**AGENDA OF THE PLANNING BOARD**

**July 1, 2021**

**10 Market Street (Grid #6158-14-300255) – JSK Rentals LLC (Jeffrey Knipe) (Owner and Applicant), Michael Gillespie of M. Gillespie & Associates Consulting Engineering P.L.L.C. (Engineer) – Reconstruction.**

Re: 2695 West Main Street  
Mixed Use Building  
Site Plan

ROOF DECK DETAIL: ALUMINUM RAILING WITH GLASS PANELS  
NOT TO SCALE

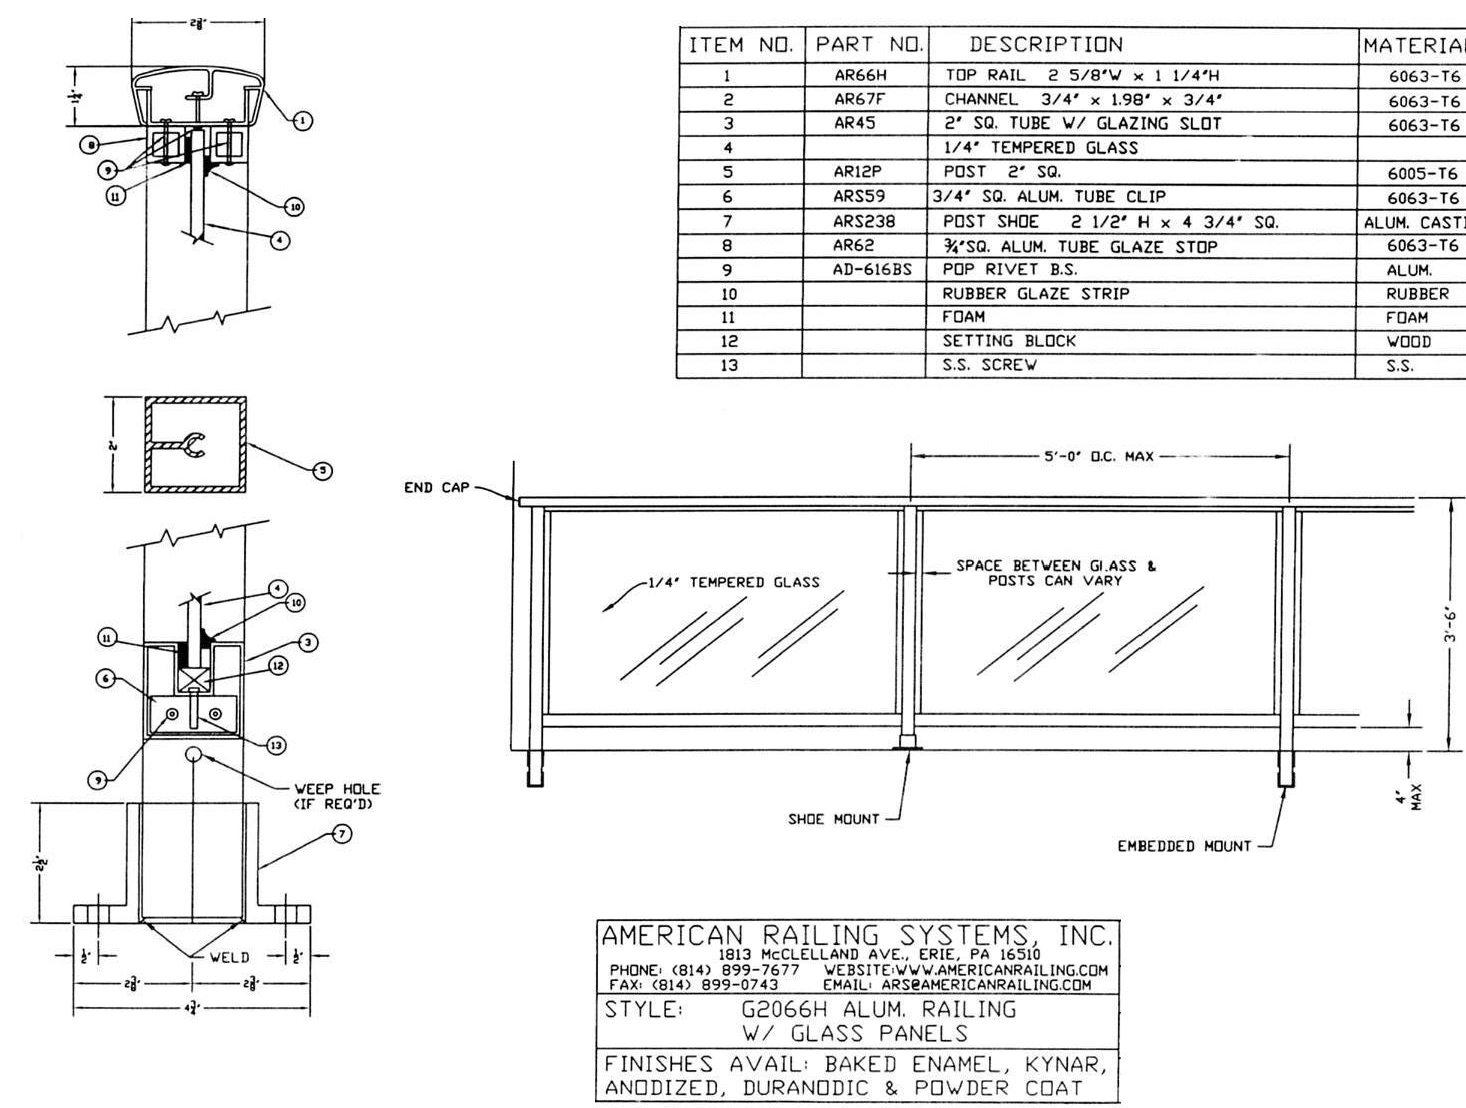
8. Rooftop Deck. A rooftop deck has been added to the plans.

1. **Rooftop Deck:** Minimal details were provided regarding the proposed rooftop deck area. The elevations appear to show a freestanding roof structure but no walls or door to accommodate rooftop access. The fenced area extends very close to the western edge of the roof, which could present a safety hazard. No details of the proposed railing are included. Additional details and more fully developed renderings could help illustrate the full scope and potential impacts of the rooftop deck. We encourage the Village to carefully review this component to ensure any rooftop structure and programming meet safety standards and the intent of the district.

**Response:** See details of rooftop deck area and railings on Proposed Roof Plan on Sheet 2 of 4, Proposed Elevations on Sheet 3 of 4, and Details on Sheet 4 of 4.

**Response:** See details of rooftop deck area and railings on Proposed Roof Plan on Sheet 2 of 4, and Proposed Elevations on Sheet 3 of 4.

2 WOODEN REFUSE ENCLOSURE FENCE DETAIL  
NOT TO SCALE

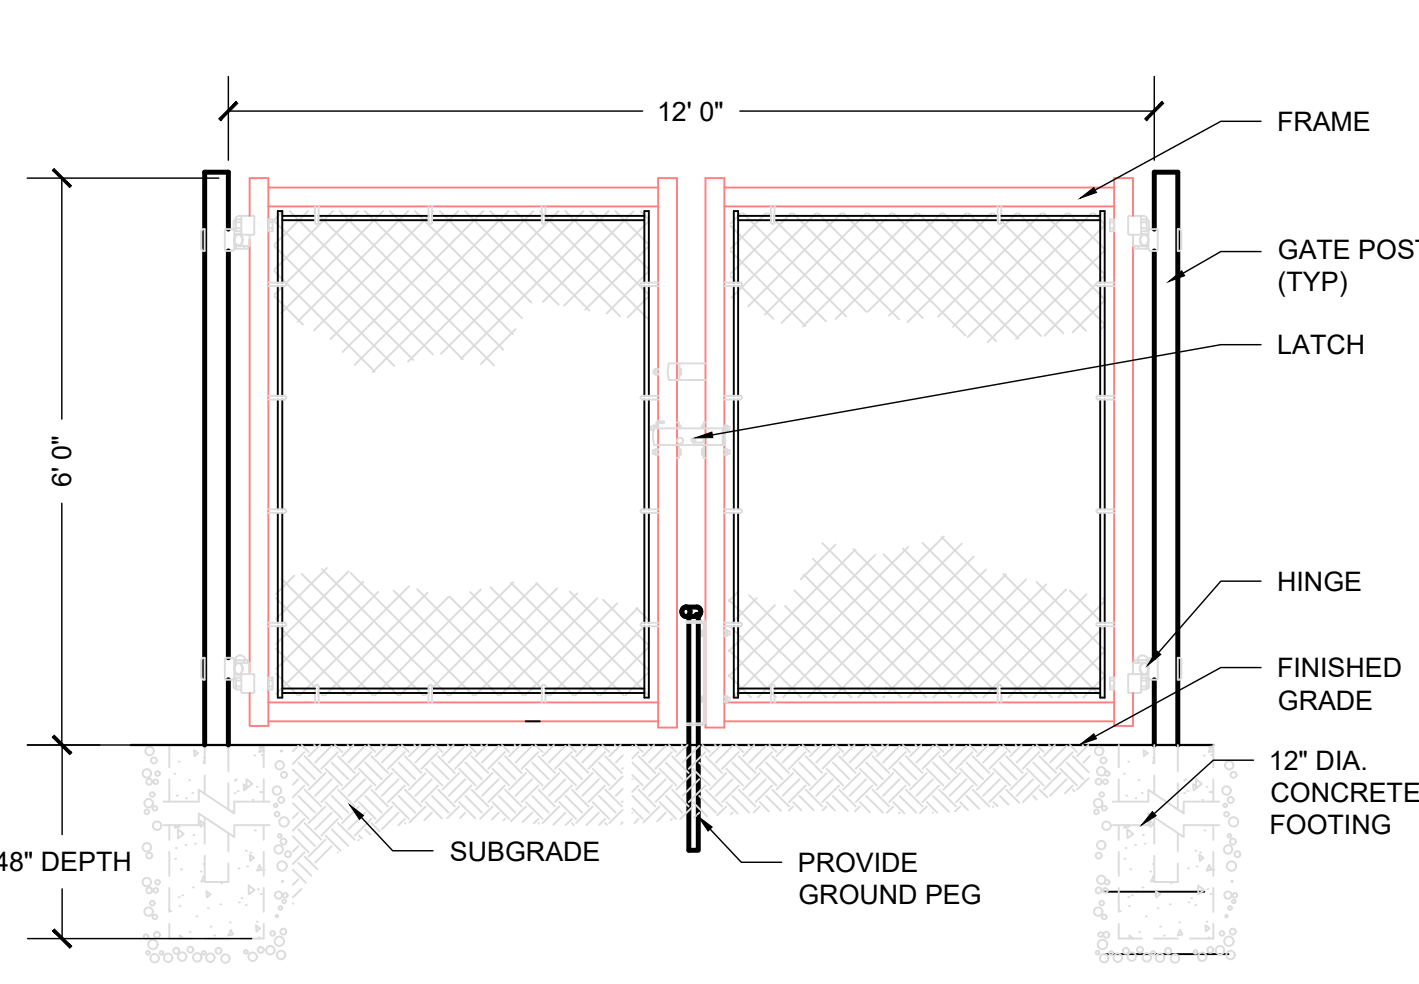
6. The proposal has been revised to include pressure treated wood painted white for the refuse enclosure. Detail 2 on Sheet 2 should be revised to refer to "Refuse Enclosure Fence," rather than "Wooden Privacy Fence."

3 CHAIN LINK DOUBLE GATE  
NOT TO SCALE

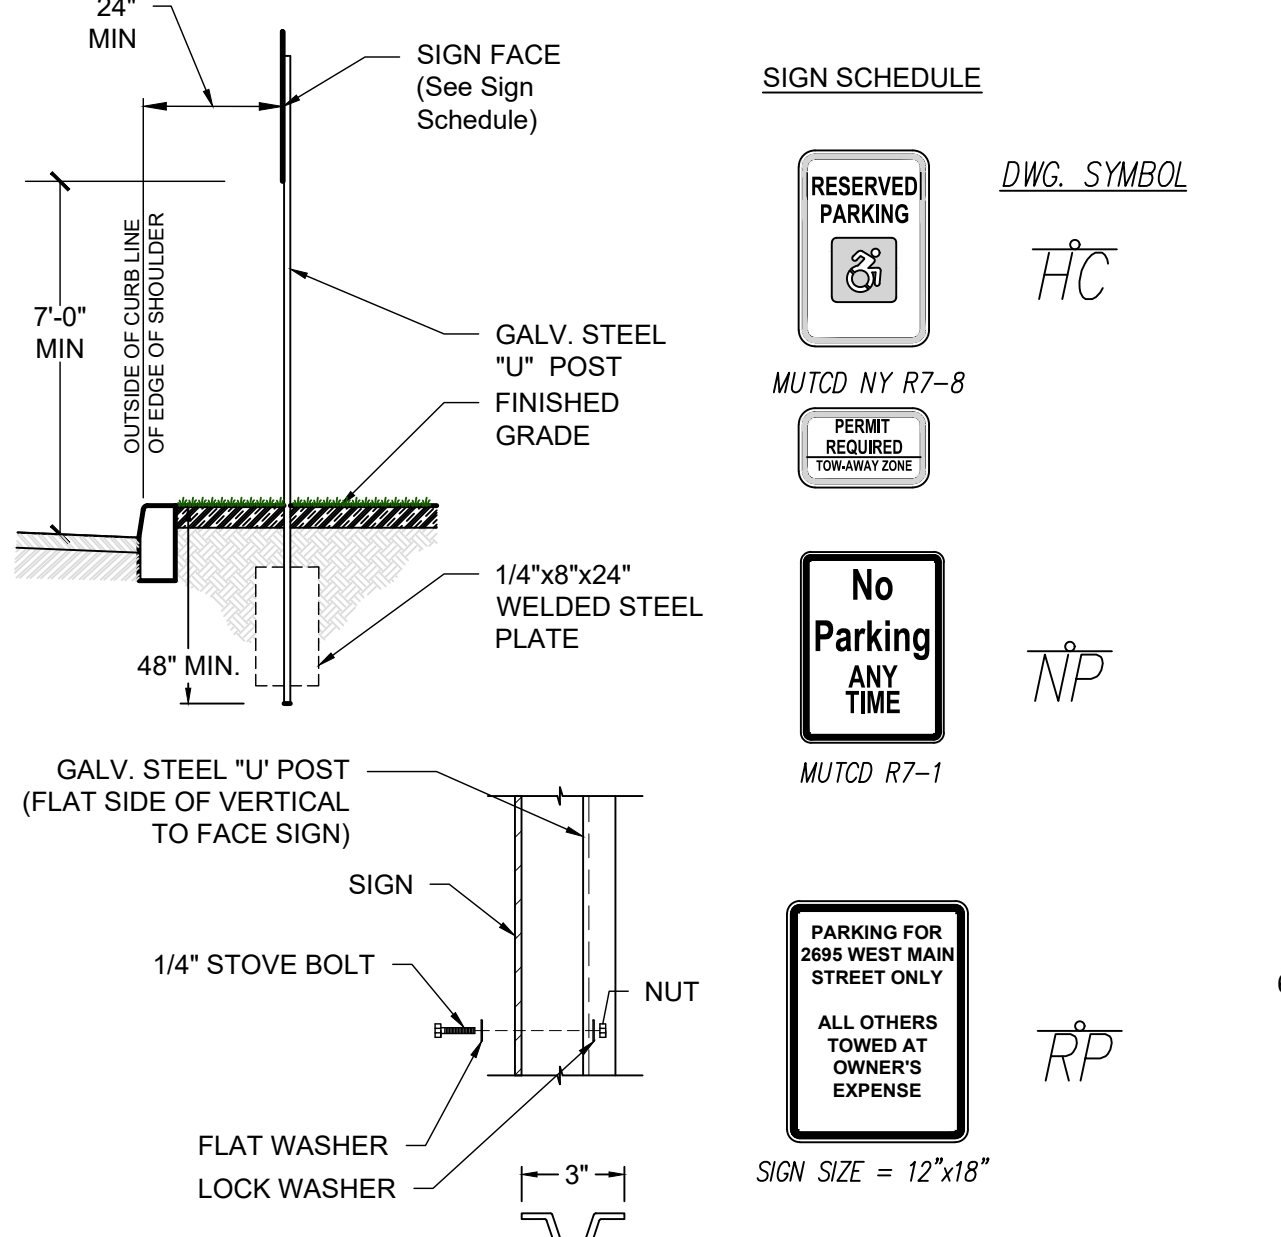
c) The dumpster screening/enclosure is listed as 8' high, but the chainlink gate is only 6' high. Please clarify.

**Response: The detail has been revised. The intention is that 6' high fence will be provided given final use as residential style bins being stored.**

8 TYPICAL REDDI ROCK GRAVITY RETAINING WALL  
NOT TO SCALE

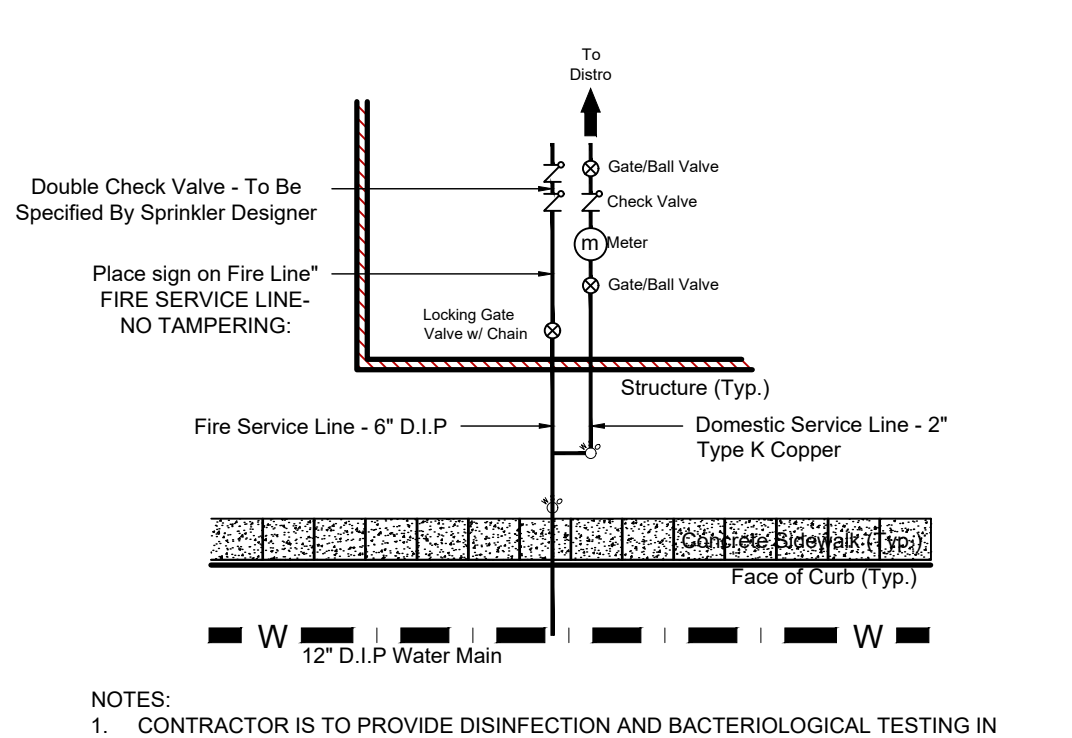
- c) The detail calls out a drainage swale just behind the wall. The swale needs to be shown on the plan view.

**Response: A swale has been called out on the plan.**

**PROPOSED LIGHTING PLAN**  
SCALE: 1" = 20'

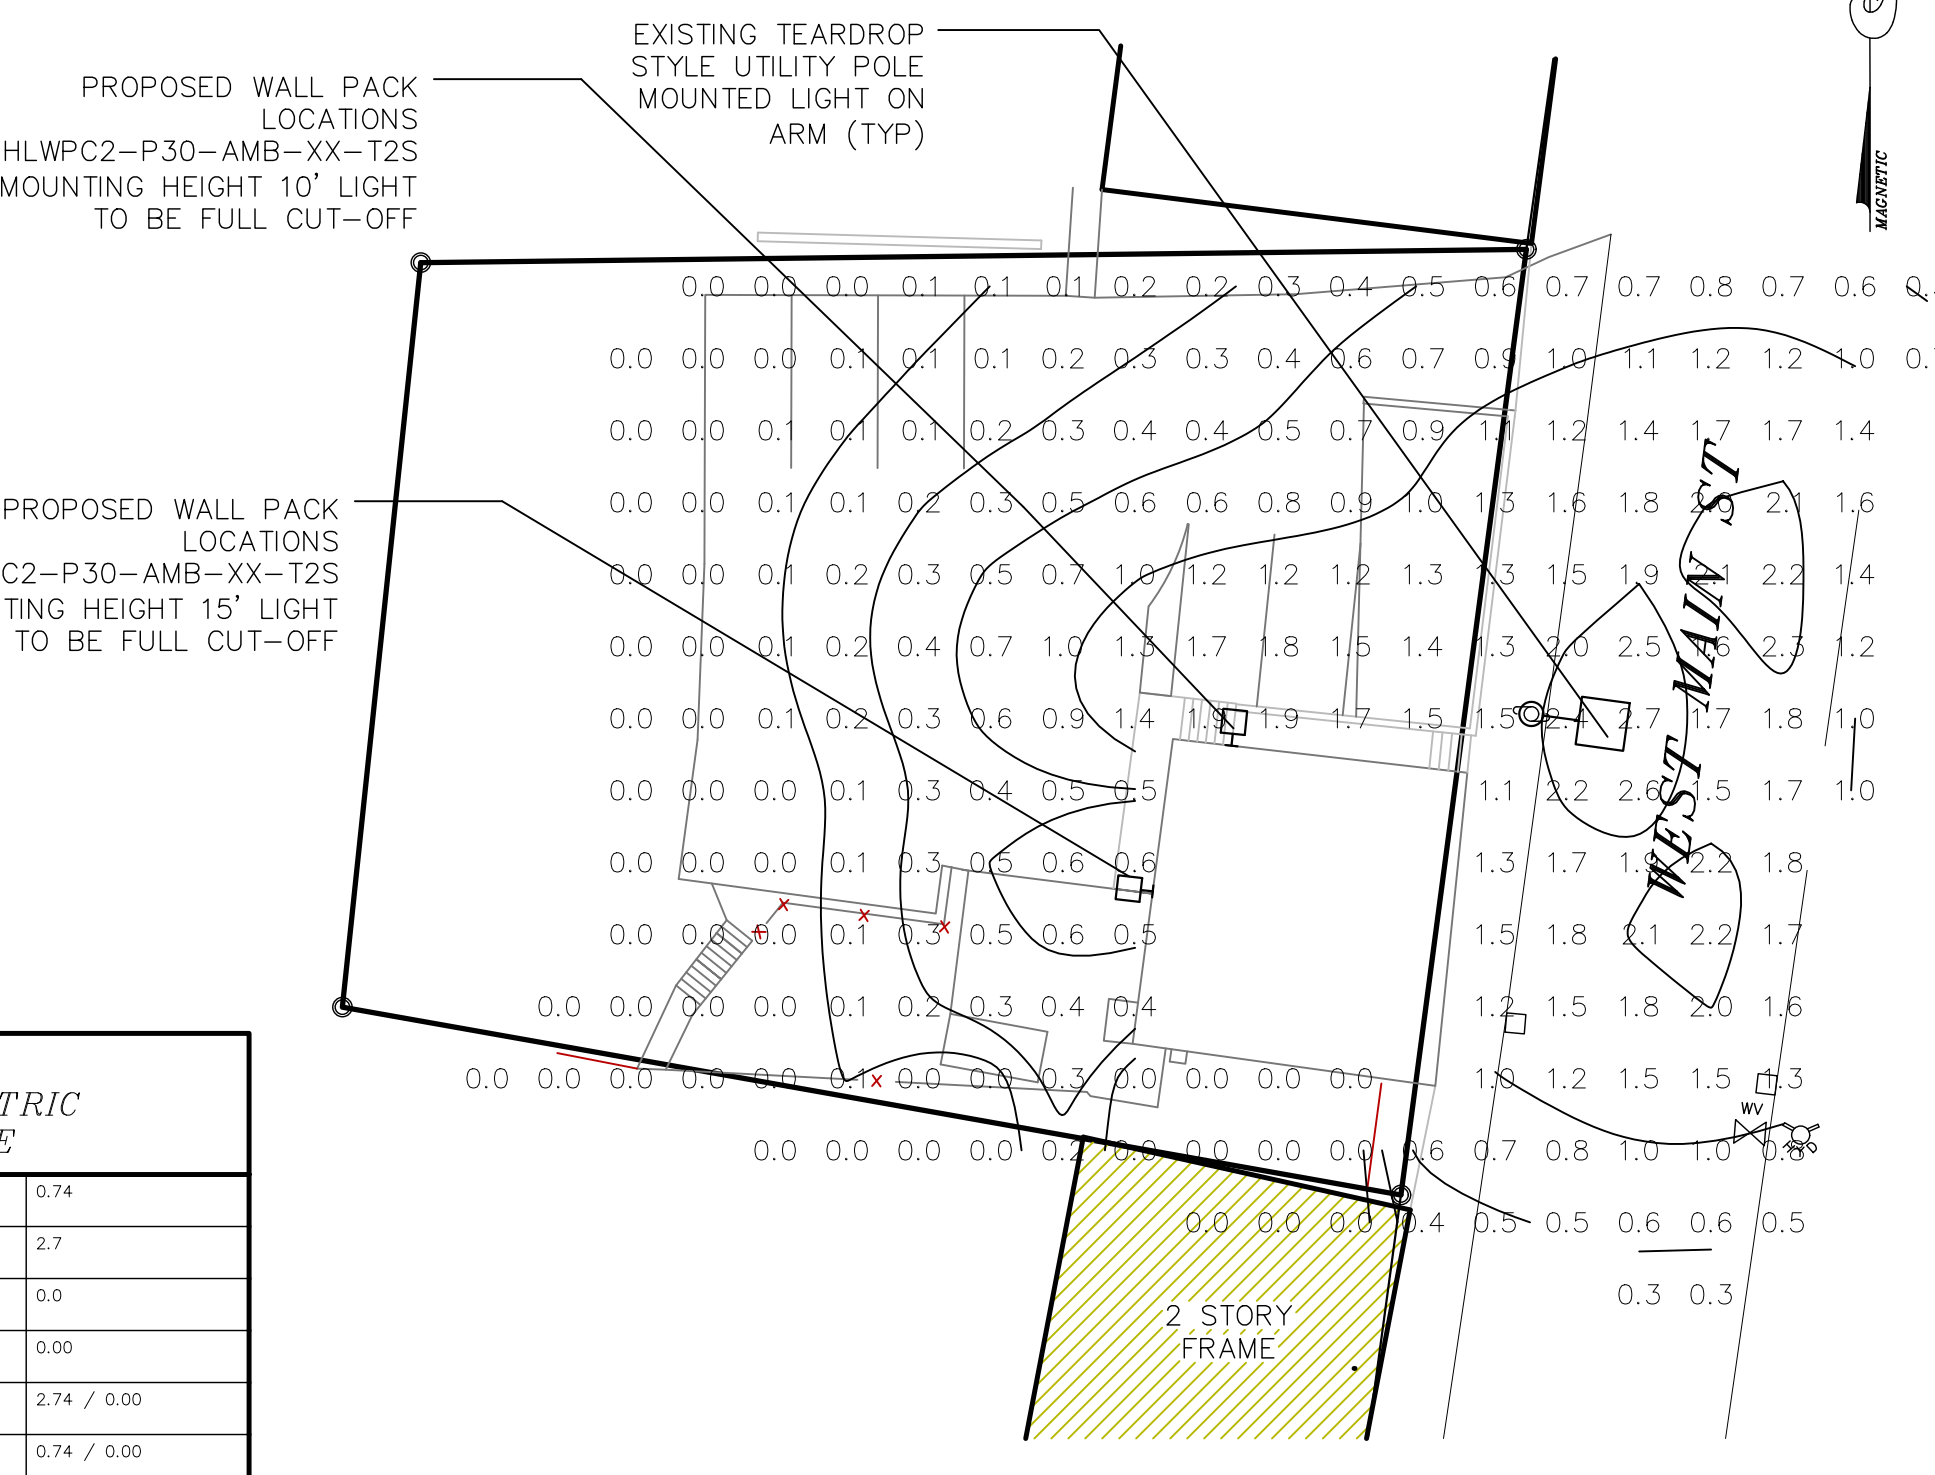
2. **Lighting:** Minimal lighting details were provided (on sheet P-1). Any lighting should be fully shielded (per Village Code §151-12(D)(8)) and dark-sky compliant to reduce glare and light pollution and should provide a range of just 0.1 to 1.0 footcandles in parking and pedestrian

**Response:** See lighting level information on Sheet 2 of 4, as well as the fixture detail. Village Code compliance note also added.
